# FY 2018-19 Standard Plans Update Training

Derwood Sheppard, P.E.
Standard Plans Publication Engineer
Central Office, Roadway Design
(850) 414-4334
Derwood.Sheppard@dot.state.fl.us

STANDARD PLANS FY 2018-19 REVISIONS LOG

GUARDRAIL SECTIONS

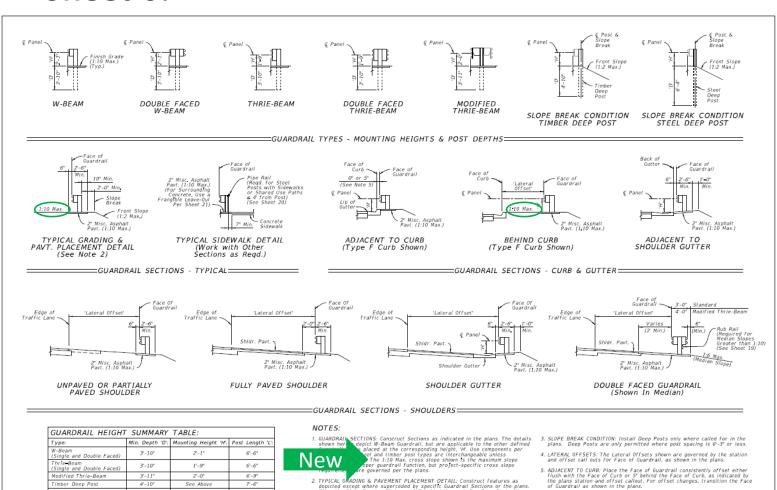
- Removed "1:10 Max." cross-slope on Shoulder Depictions
- "1:10 Max." does not conflict with FDM requirements, but...
  - Removal avoids misconception that "1:10 Max." supersedes Plans and FDM requirements

TYPICAL GRADING & PAVEMENT PLACEMENT DETAIL: Construct features as
depicted except where superceded by specific Guardrail Sections or the plans,
Place the Stope Break a Minimum of Z behind the post. For Deep Post, the
slope break may be placed at the § Post with the Z\* Miscellaneous Asphalt
Pavement omitted.

note explaining "1:10 Max." is for guardrail function only; the slope shown in Plans governs (FDM) requirements)

#### Sheet 16:

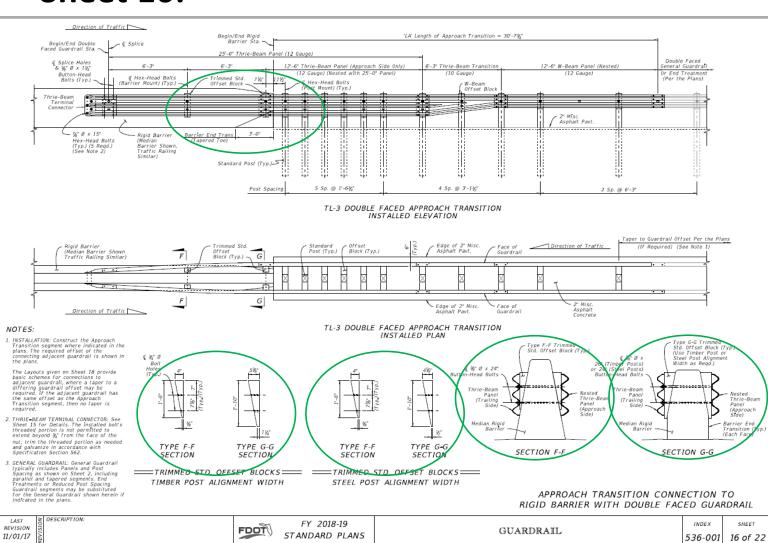
- Example of
  Changes for
  Single-Slope
  Barrier (which
  show up on
  numerous
  other Sheets)
- Barrier Height now Tapers
   Down for GR
   Connection
- Offset Blocks Revised
- Overall
  Guardrail
  System Width
  Unchanged!

#### Sheet 20:

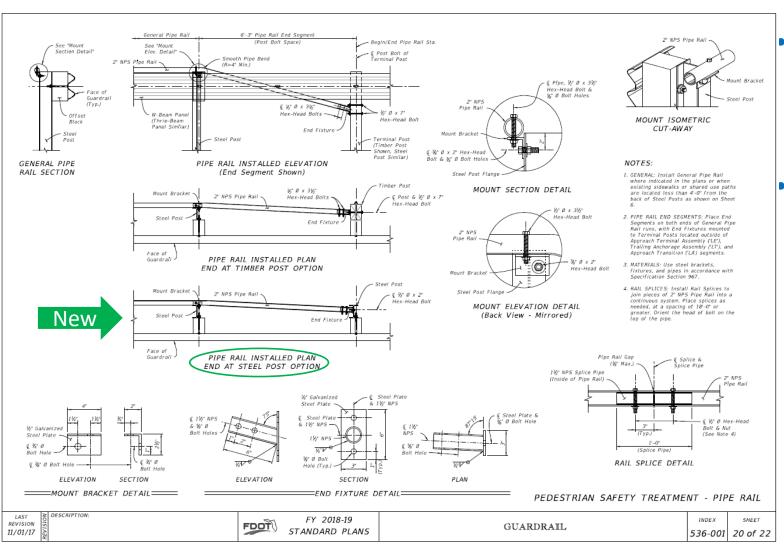
- Added Option to Terminate Pipe Rail on Steel Post
- If Pipe Rail is no longer needed because a sidewalk veers greater than 4 feet from guardrail, a timber post is no longer required within the steel post run.

#### **Sheet 2: Revised!**

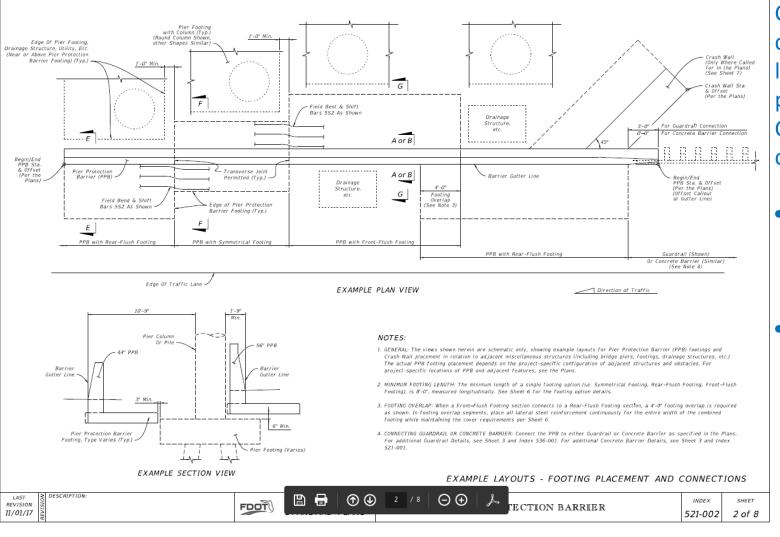
Crash Wall connection to PPB location differs per Guardrail or Concrete Barrier connection:

#### **Sheet 6: Revised!**

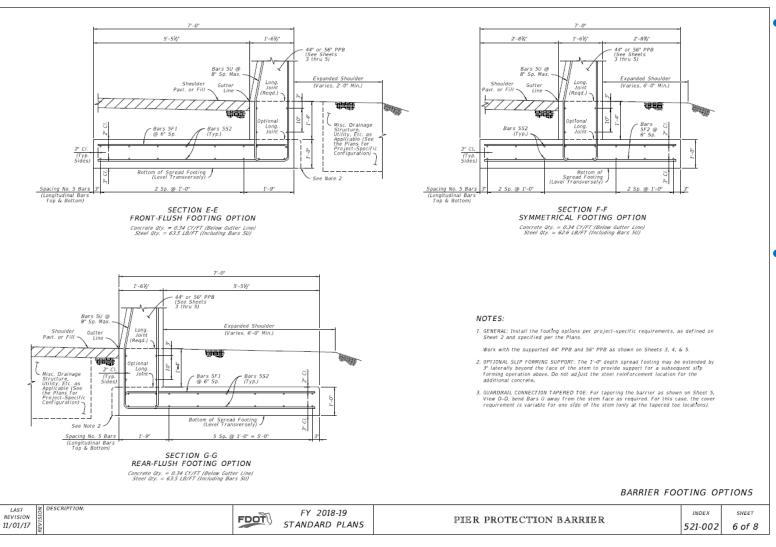
- Differing footing options for fitting around piers, drainage, utilities, etc...
- Same dimensions as FY 2017-18 Standard

#### **Revisions for Single-Slope Sheet 1:**

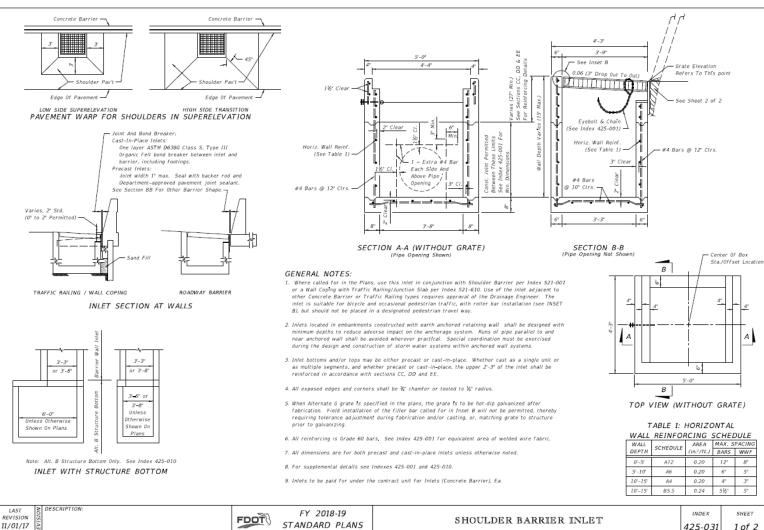
- Removed upstream "throat" indentation
- Reduced inlet Type quantity from 5 to 2
  - Clarified Label: Type 1 inlet for symmetrical barrier only

### **Sheet 2: Revised for Single-Slope**

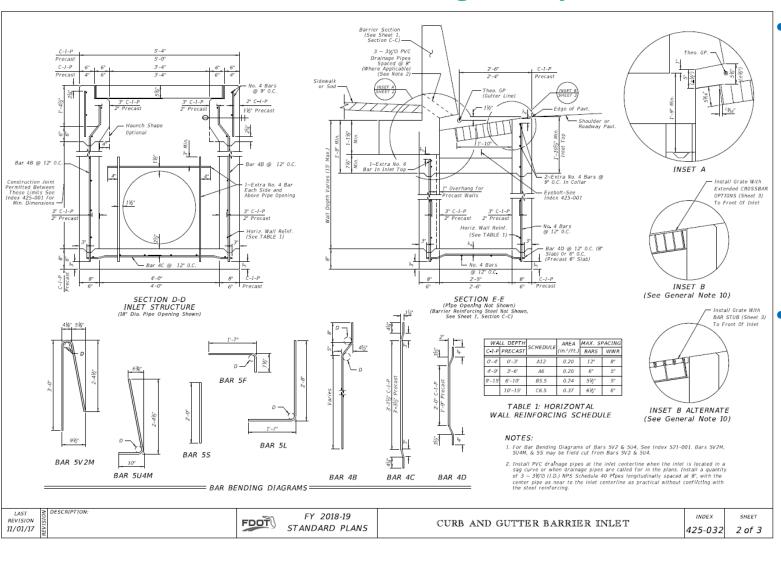
- Replaced 18"
  drainage slot
  with 3 ~ 3.5"
  PVC pipes
  (improved
  constructability, less
  interference
  with rebar)
- Revised reinforcing

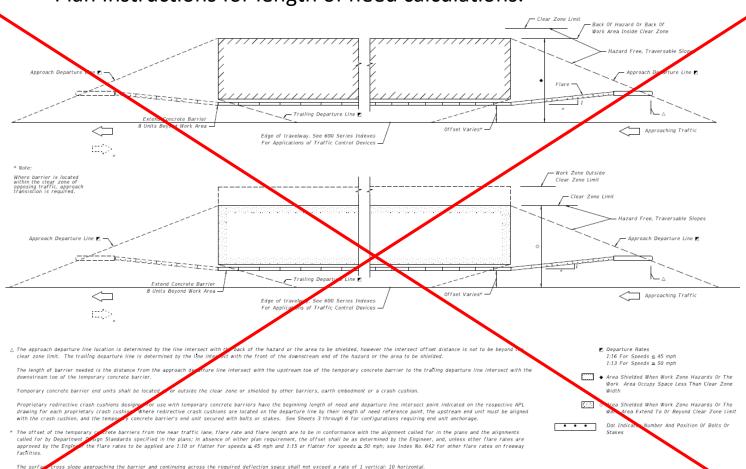
- This index is now generic to multiple types of temporary barrier systems.
- 1. Temporary concrete barrier systems on roadways may be any of the following:
  - a. The FDOT Type K Temporary Conc. etc Barrier system (Design Standard Index 414). F-Shape Units. For temporary concrete barrier systems on bridge Sections Standard Index No. 414.
  - b. Proprietary temperary concrete barrier systems meeting NCHRP Report 350 Test Level 3 criteria which are included on the Approved Products List.
    - c. water rilled barrier (rree-Standing)
- "Deflection Space" is now "Setback Distance" and the previous table has been revised and simplified. Anchored "Setback Distance" was previously as low as 1' and is now 2'.

# Index 102-606 (previously Index 606) "Two-Lane, Two-Way, Work Within the Travel Way – Signal Control"

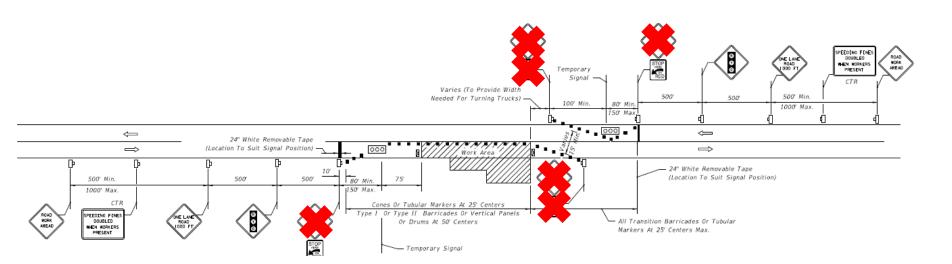
> Removed "Reverse Curve" and "Keep Right" signs from all sheets.

## Index 546-010 (previously Index 518) "Ground-In Rumble Strips"

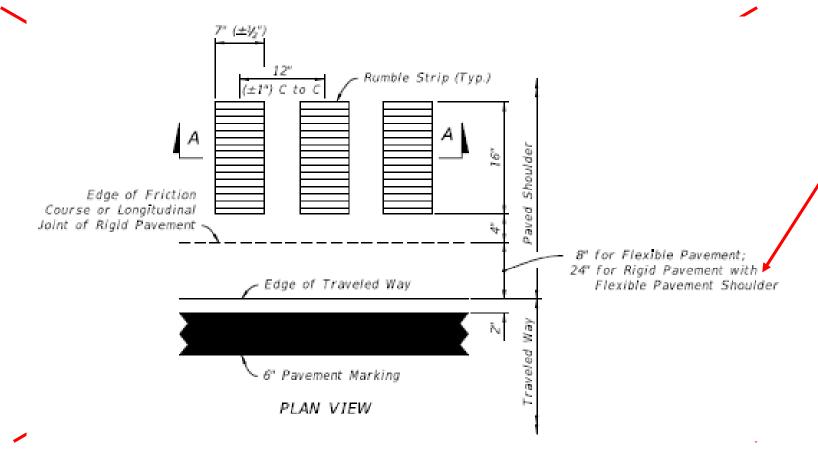
➤ The concrete pavement details on the old sheet 2 of 2 have been removed. The "Rigid Pavement with Flexible Pavement Shoulder" detail has been incorporated into "Detail 'A'" of the Standard Plan. The Profiled Thermoplastic criteria has been moved to FDM 211.4.4.2.

# Index 700-020 (previously Index 11200) "Multi-Column Ground Sign" Sheet 1 of 3

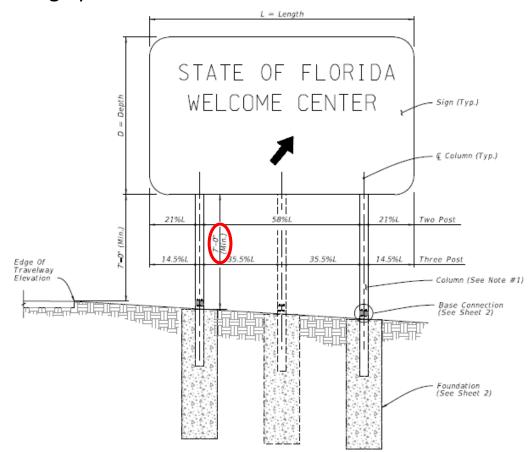
- Deleted 8' (Max.) requirement.
- Added 7' (Min.) requirement for length of post from base connection to bottom of sign panel.

### Index 711-001 (previously Index 17346) "Pavement Markings"

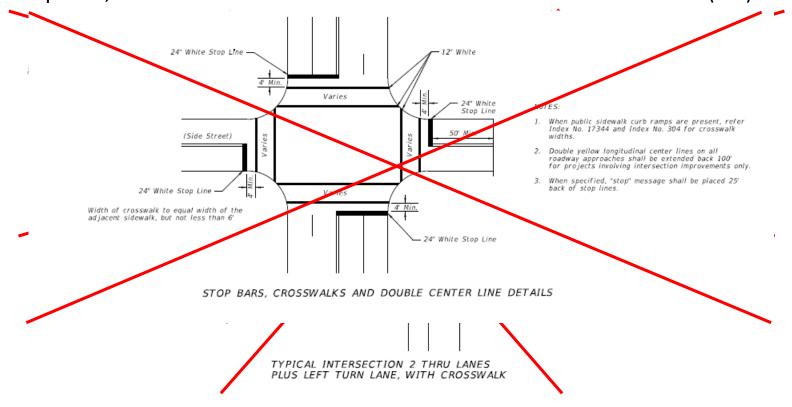
- > Removed the following details:
  - "Typical Crosswalk Markings for Curb Ramps" on sheet 6 of 17 (old)
  - "Restricted Left Turn Marking" on sheet 7 of 17 (old)
  - "Typical Intersection 2 Thru Lanes Plus Left Turn Lane, with Crosswalk" on sheet 7 of 17 (old)
  - "Stop Bars, Crosswalks and Double Center Line Details" on sheet 7 of 17 (old)

## Index 711-001 (previously Index 17346) "Pavement Markings"

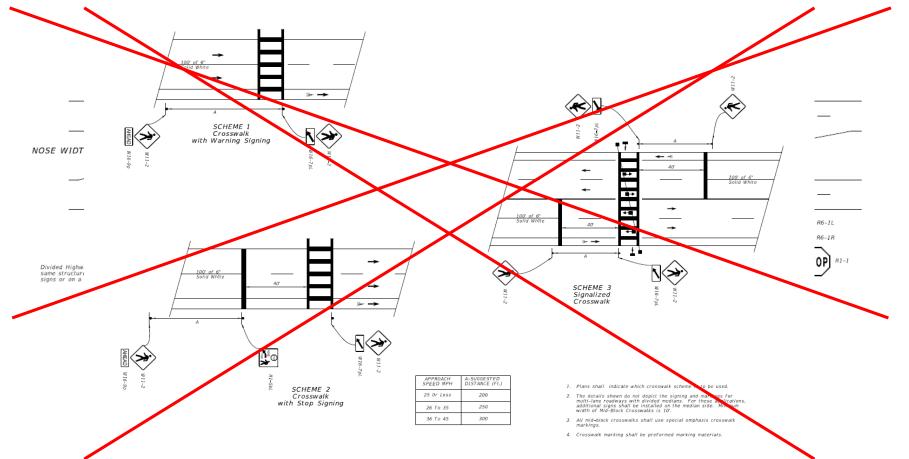
- Removed the "One-Way Signs on Divided Highway Intersections" detail on sheet 8 of 17 (old) placed it in FDM 230 as an exhibit.
- ➤ Removed the sheet with Midblock Crossing details (old sheet 13 of 17) and placed it in FDM 230 as an exhibit.

## Index 711-001 (previously Index 17346) "Pavement Markings"

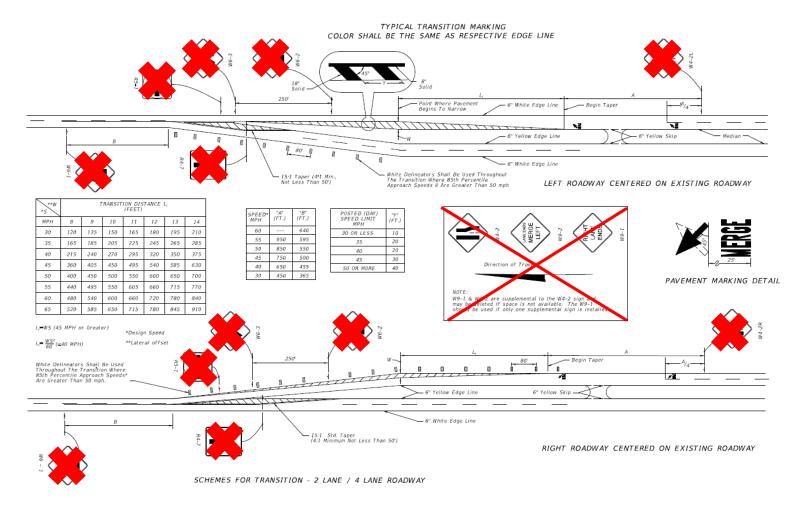
➤ Removed the signing details from "Schemes for Transition – 2 Lane / 4 Lane Roadway" on sheet 9 of 17 (old) and placed them in FDM 230 as an exhibit.

# Index 711-001 (previously Index 17346) "Pavement Markings"

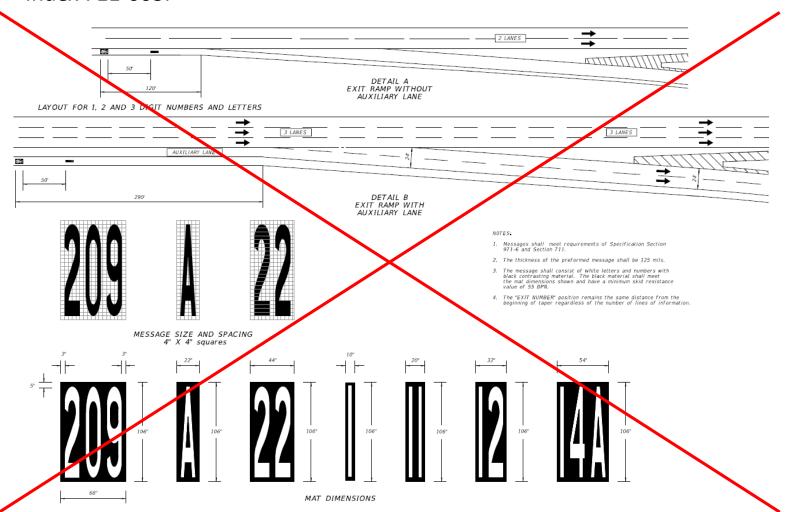
Removed sheet with exit number details (old sheet 10 of 17) and placed it in Index 711-003.

## Index 711-001 (previously Index 17346) "Pavement Markings"

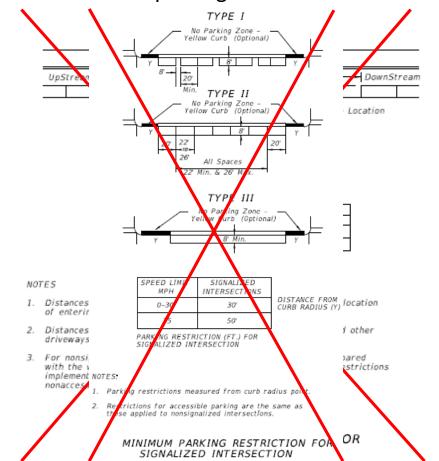
- Removed the following details from sheet 15 of 17 (old):
  - "Minimum Parking Restriction for Nonsignalized Intersections"
  - "Minimum Parking Restriction for Signalized Intersection"
- > See FDM 212.11.5 for on-street parking at intersections.

# Index 711-001 (previously Index 17346) "Pavement Markings"

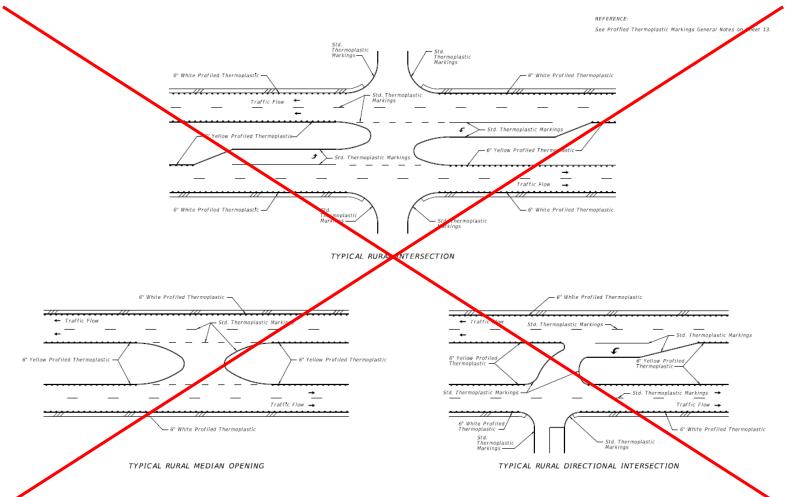
➤ Removed sheets with Profiled Thermoplastic details (old sheets 16-17 of 17). See FDM Figure 210.4.4 for the placement of audible and vibratory treatment.

# Index 711-002 (previously Index 17347) "Bicycle Markings"

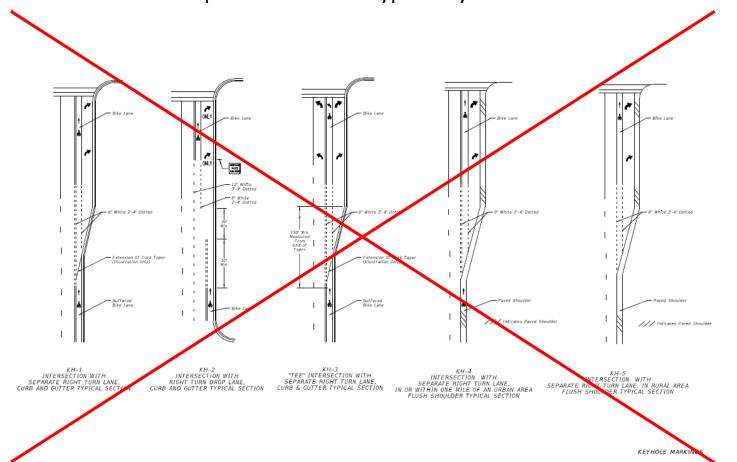
- Removed sheet with "Shared Lane Markings" details (previously sheet 2 of 5). See FDM 223.3 for guidance on Shared Lane Markings.
- ➤ Removed sheets with bike lane typical layouts (previously sheets 4-5 of 5). See FDM 223 exhibits for updated bike lane typical layouts.

# Index 711-003 (previously Index 17345) "Interchange Markings"

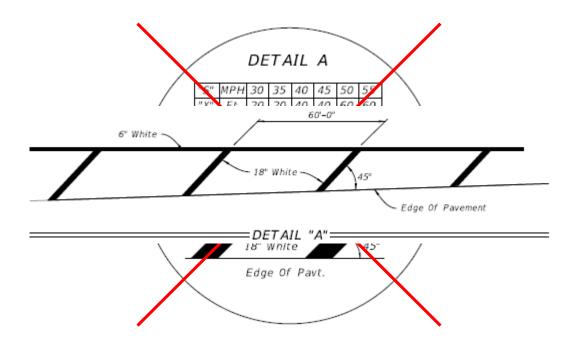
- > There are Index-wide changes for consistency, but most are relatively minor.
- > Revised the chevron spacing chart on sheet 1 of 1. All chevron spacing is now 60'.
